Subject: Docket Nos. 50-361 and 50-362
San Onofre Nuclear Generating Station, Units 2 and 3

ATTACHMENT I

Notice of Violation

POST-WELD HEAT TREATMENT PROCESSES

Figure B-1. INTERNAL HEATER TEST ASSEMBLY

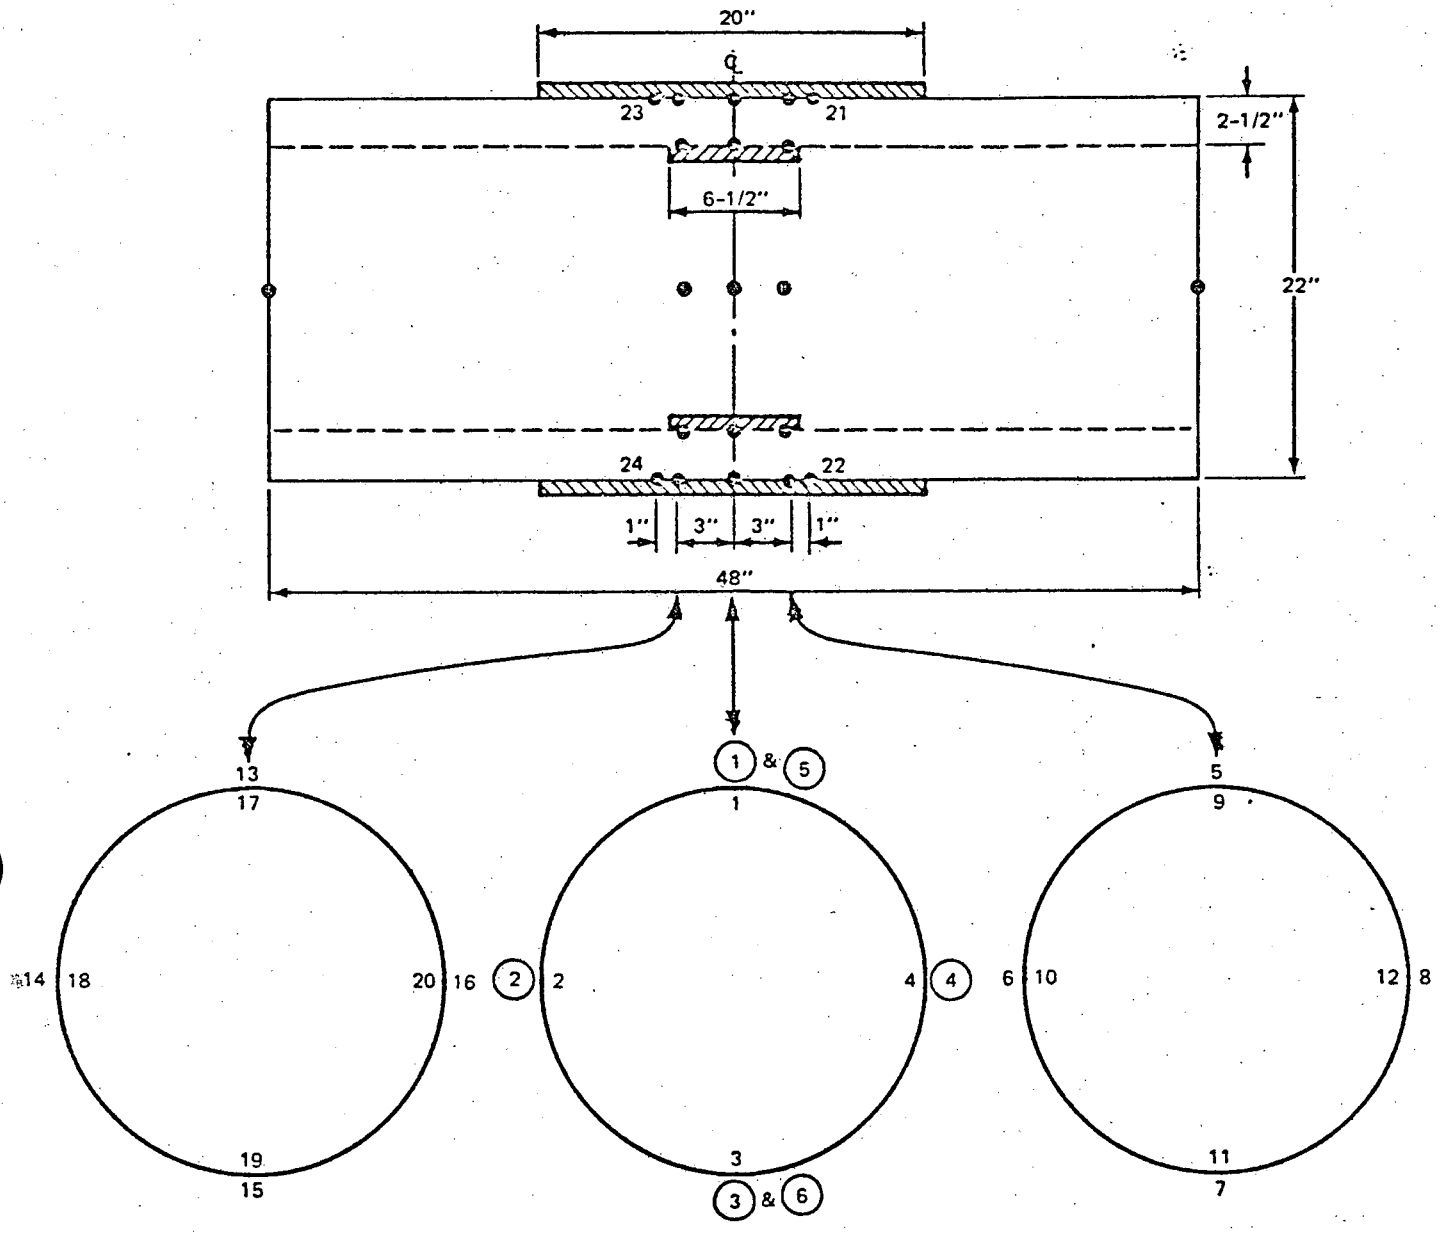
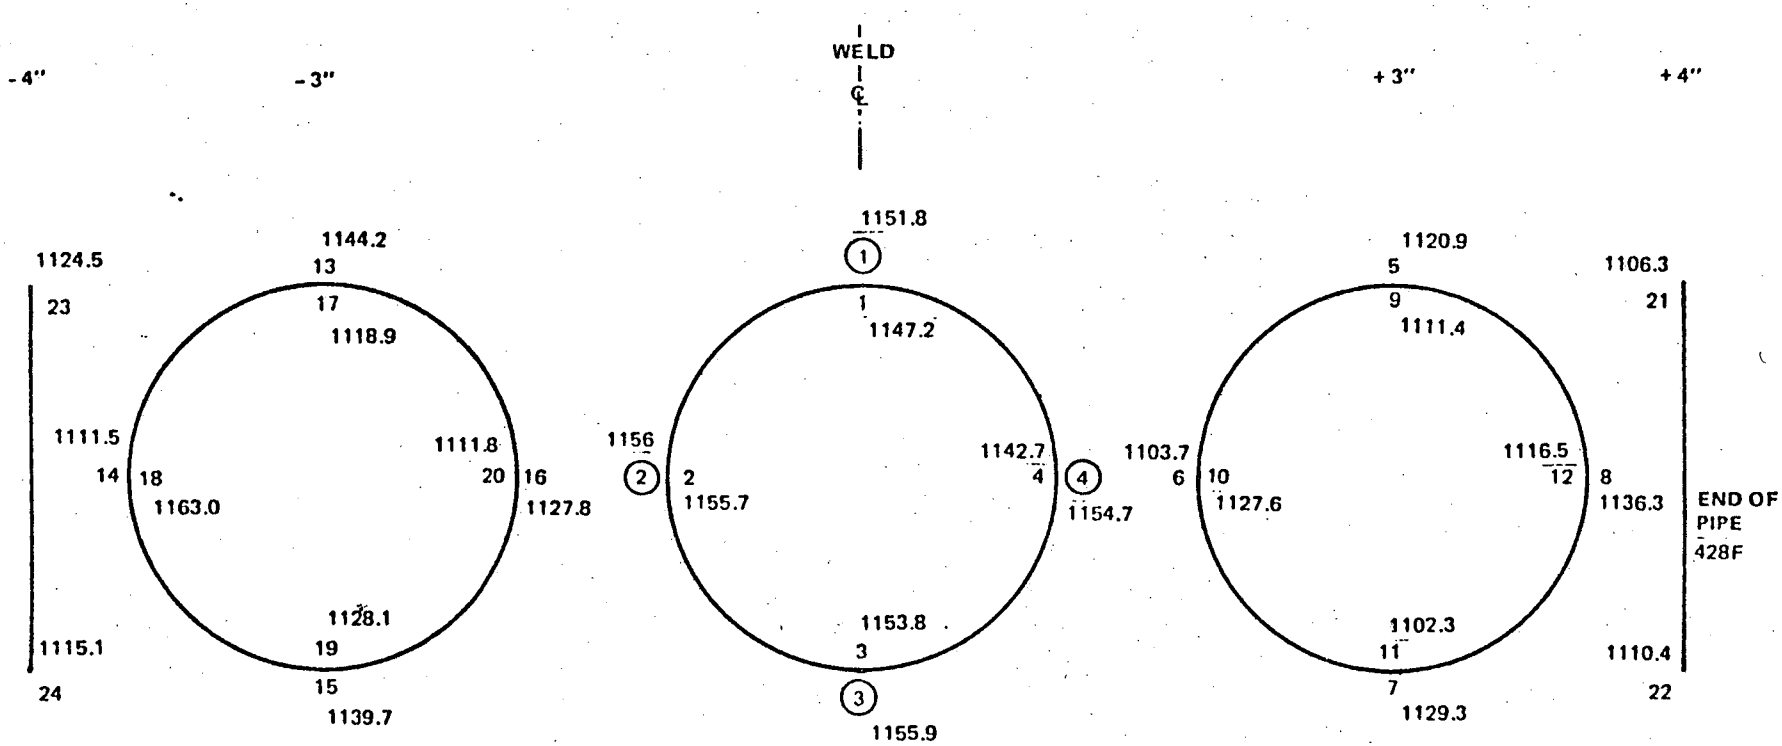
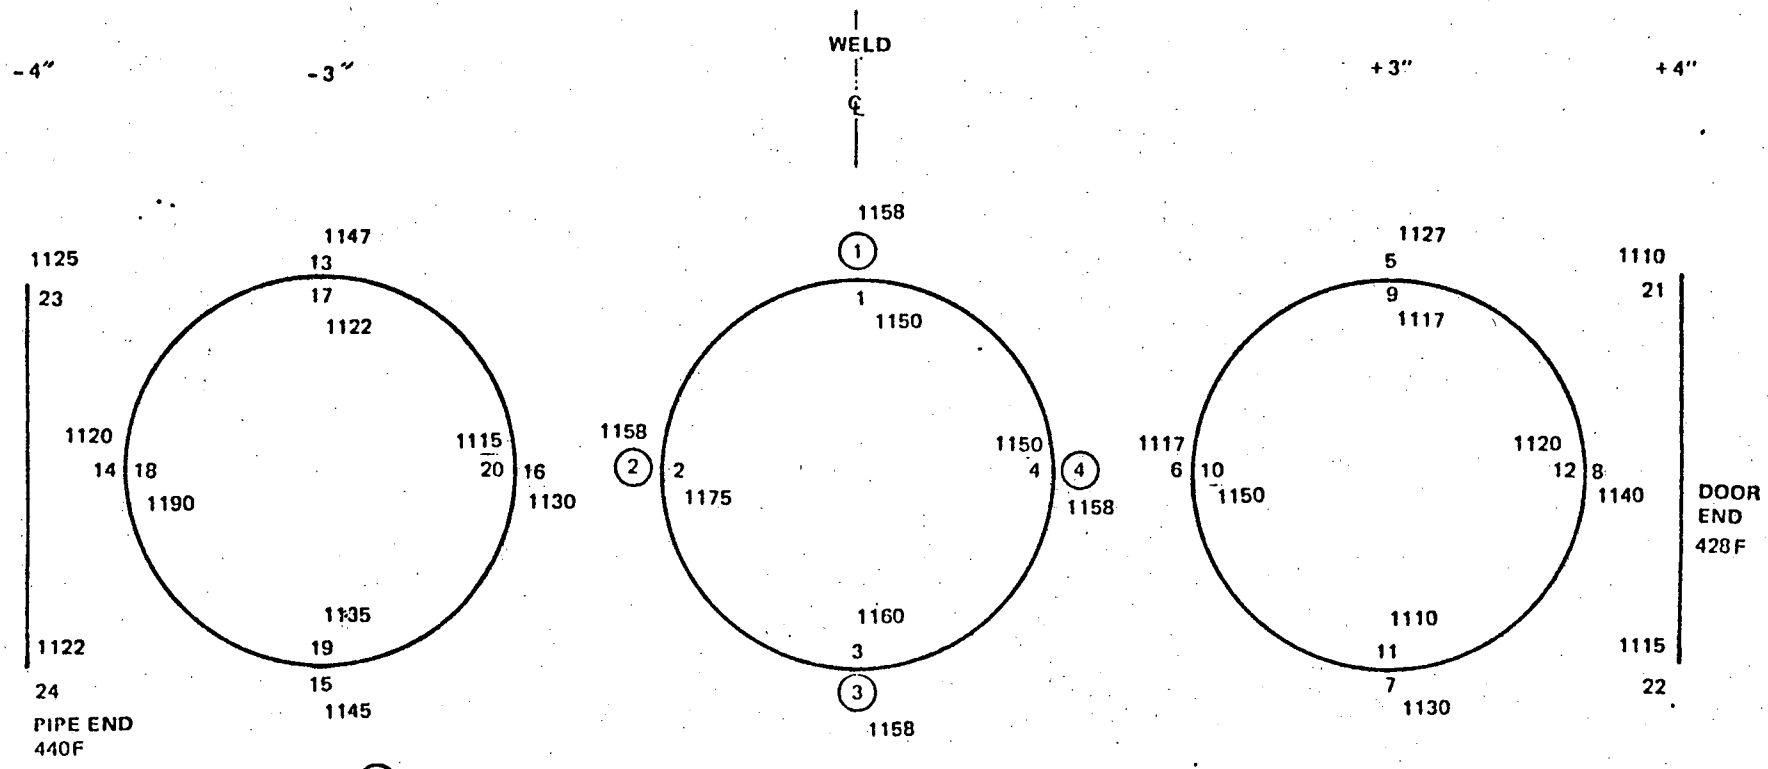
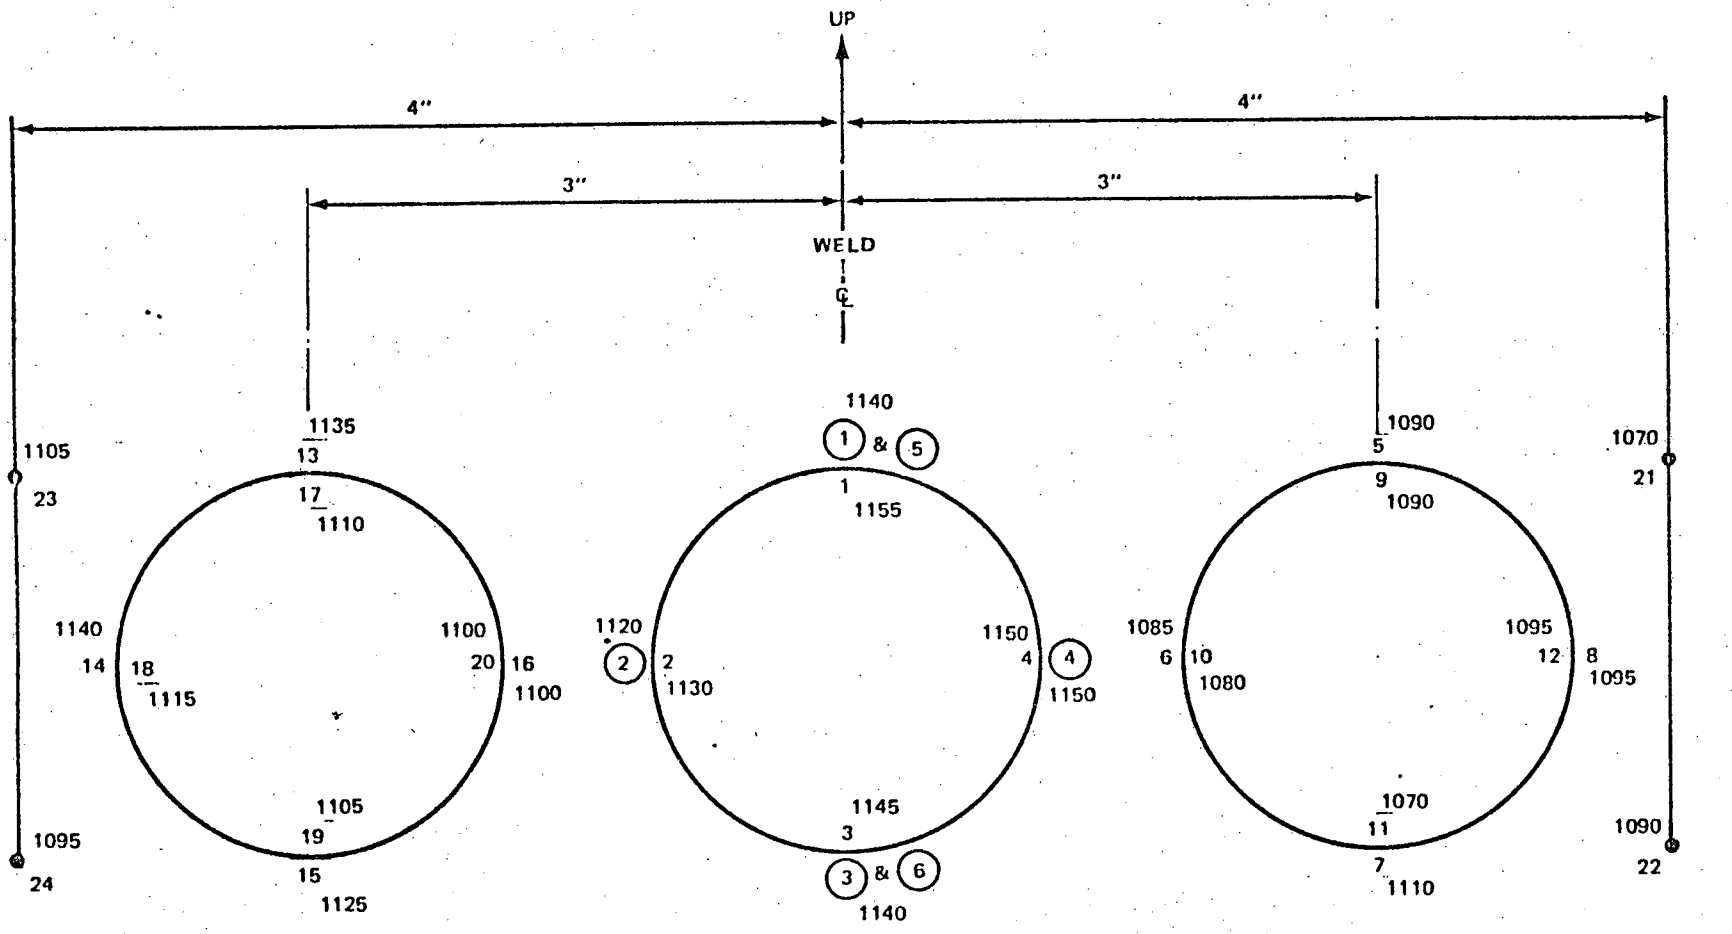
Contrary to the above, as of February 5, 1979, the post weld heat treating procedure using the quartz lamp technique had not been qualified before use to demonstrate that the minimum heat treating temperature of 1100°F, a design requirement, was met during the post weld heat treatment of main steam piping and reactor coolant piping welds. This procedure had been used since mid-1977 for heat treating the aforementioned welds at Units 2 and 3.

A test was conducted at the Cooperheat facilities in Mountain View, California during March 1979 to determine the maximum through-wall temperature gradient using the resistance blanket method of PWHT. The test configuration was the same as that used on San Onofre production welds with the external heater width being less than the width used in production welds for conservatism. The internal heaters were 6-1/2 inches wide and were controlled from outside surface thermocouples as is done on production welds. The test showed essentially no temperature difference through the pipe wall with internal temperatures varying from 5F cooler inside the pipe to 25F warmer inside the pipe. Test data is provided in Appendix B. It can therefore be concluded that for resistance blanket method of PWHT, maintaining the reference thermocouple at 5F or greater above the code required temperature will ensure that the internal temperature in the heat affected zone meets code requirements.
